CR163 – New layout of rear turn indicator cables on number plate holder

Multistrada 1260 Model Year 2018 (all model versions)
Technical Service Bulletin SRV-TSB-18-016

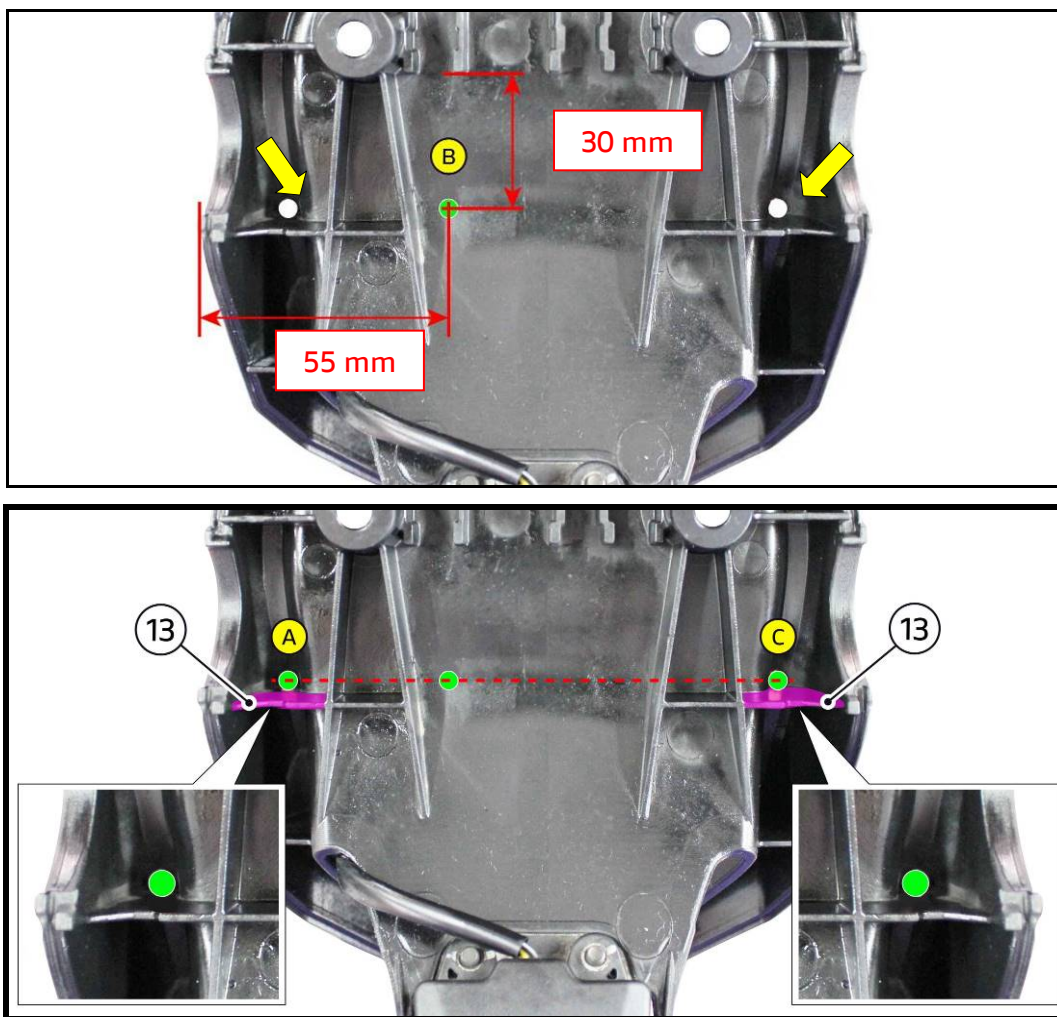
9. Using a $\varnothing$ 4 mm drill, drill **3 holes (A), (B) and (C)** at the points indicated in the figure.

The **holes (A) and (C)** must be drilled at the **ribs (13)** and at the groove on lower number plate holder, as shown below

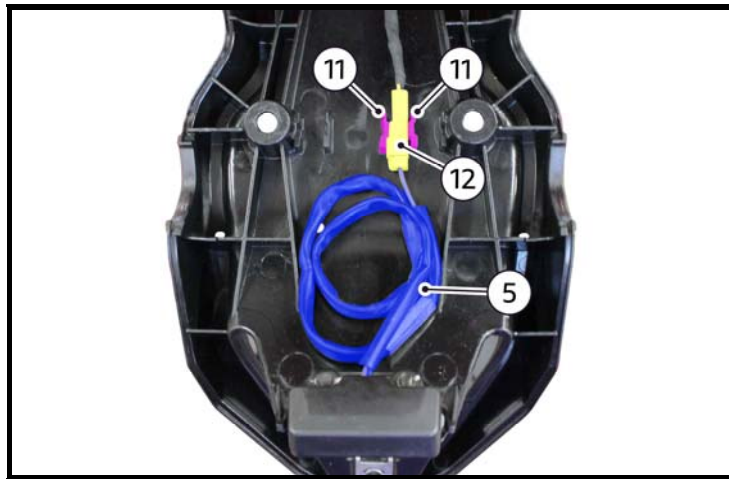
10. Fold the **number plate light cable (5)** on itself (twice), and connect the **connector (12)** to the relevant connector of number plate holder light wiring branch
11. Position **connector (12)** between **retainers (11)** on lower number plate holder as shown in the figure.

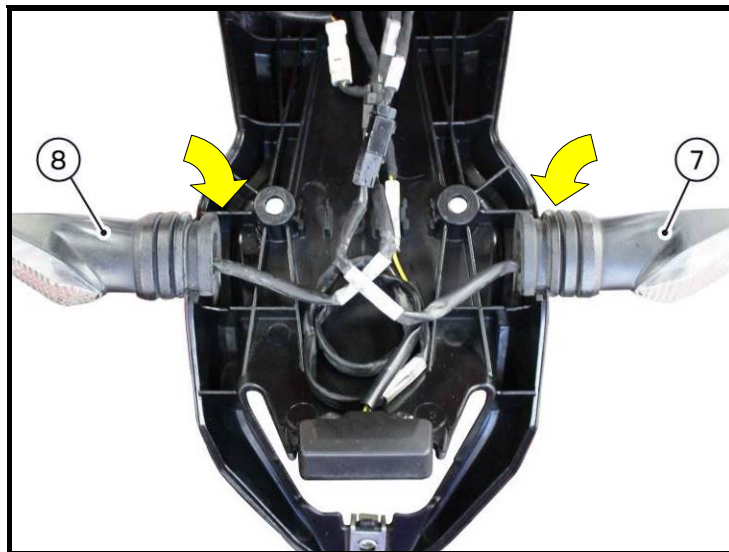
12. Fit the **RH turn indicator (7)** and **LH turn indicator (8)** in their housings on the lower number plate holder and position them as shown in the figure

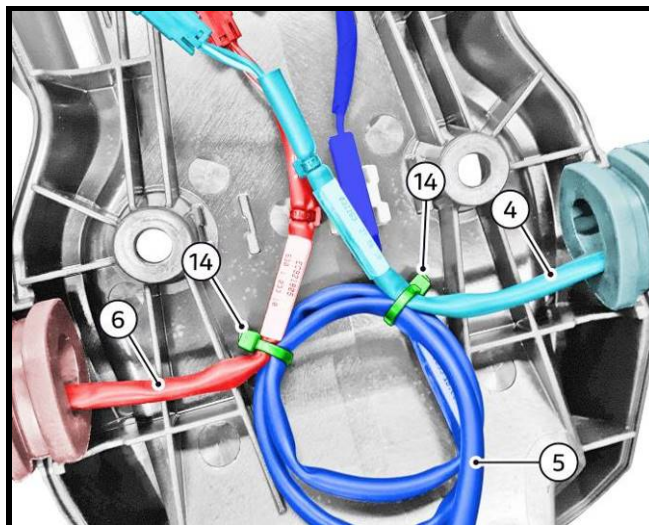
13. Tie together the RH turn indicator cable (4) to number plate light cable (5) using a small self-locking tie (14), and then the LH turn indicator cable (6) to number plate light cable (5) using a small self-locking tie (14) in the position shown.

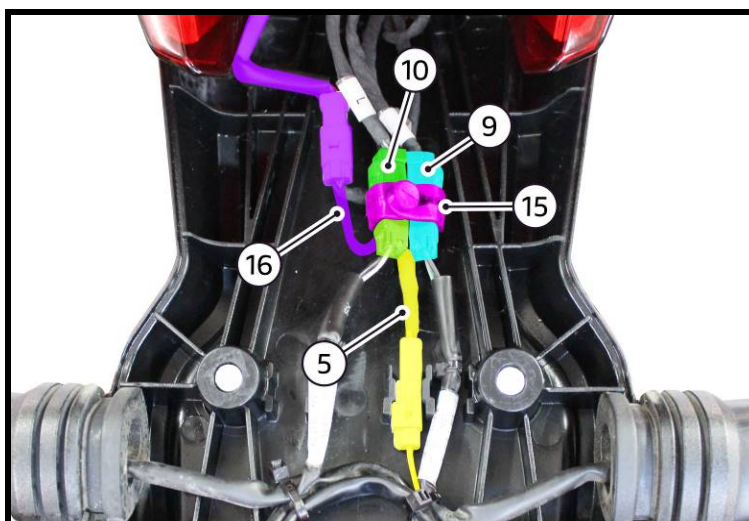
14. Use a button tie (15) L.39 mm, and tie together connectors (9) and (10) of the RH and LH turn indicators respectively, the number plate light wiring branch (5) and the tail light wiring branch (16) as shown in the figure.

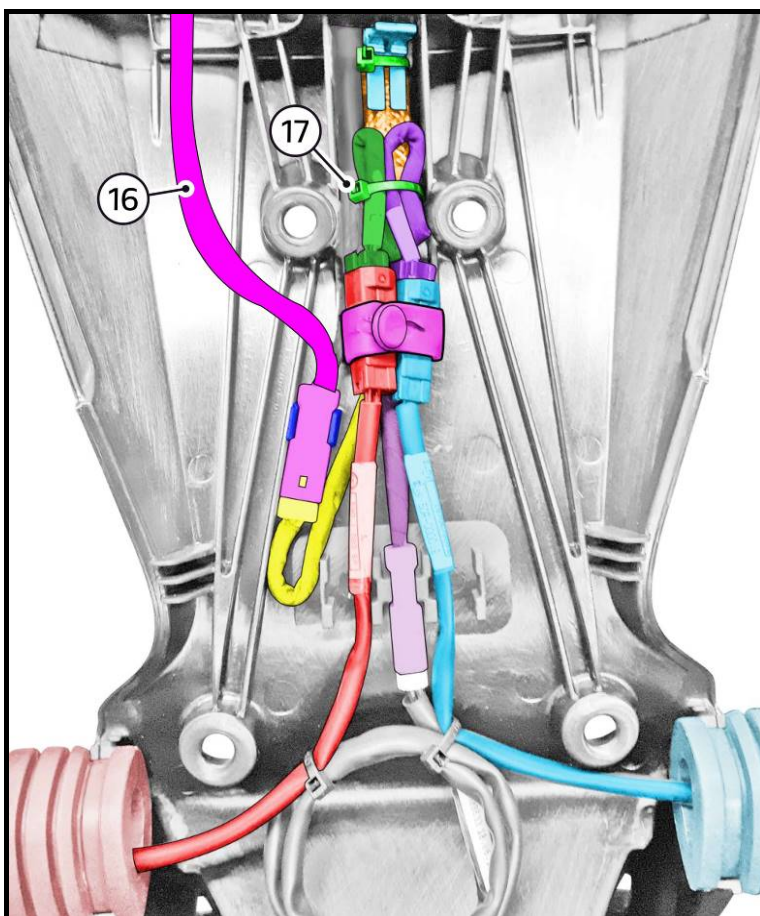
15. Tie any excess cable length of RH and LH turn indicators wiring branch to the main branch of the rear wiring using a **small self-locking tie (17)** as shown in the figure.

Check proper routing of the **tail light wiring branch (16)** inside the lower number plate holder to avoid damaging the cable while installing the upper number plate holder. Repairs to harness damage due to improper installation will not be covered by warranty
